GROUP	MODEL
Service Campaign	2015MY Cadenza (VG)
NUMBER	DATE
SC240	October 2022

VOLUNTARY SERVICE CAMPAIGN

FRONT COIL SPRING REPLACEMENT (SC240)

Front Coil Spring

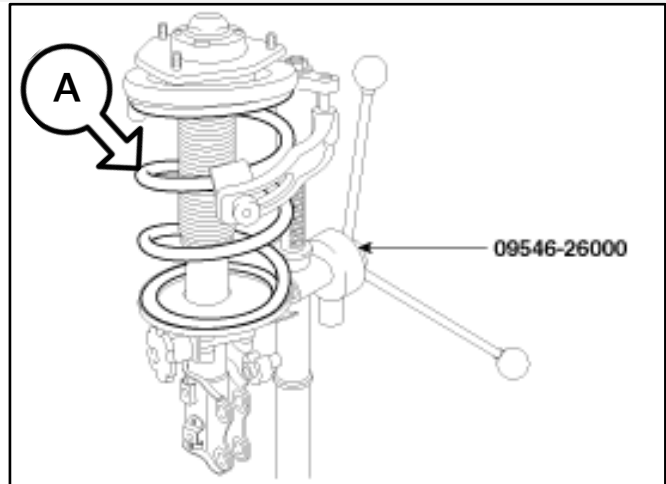
A sleeve has been added to the bottom of the coil spring to prevent corrosion.
